Access Compliance Report

Public Rights-of-Way

(Curb Ramps)

Intersection ID: 15123	Main Street: EASTWAY_DR_RA	Cross Street: EASTWAY_DR	Location: SE
ADA ID: 7B26A65356C6	Ramp Type: Perp	Initial Pass/Fail: Fail	Overall Compliance: No
Severity Score: 61.25			
Codes/Mitigation Info/Possible Solution		Field Measurements/Component Compliance

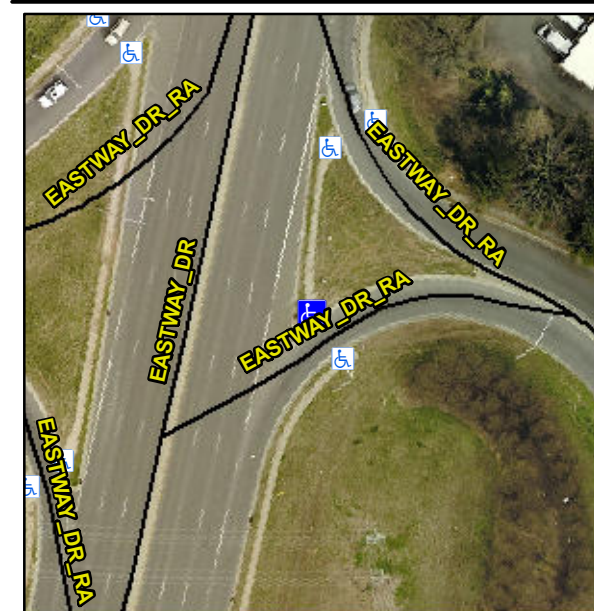
Remove & Replace Entire Ramp.

R304.5.1, R304.2.2
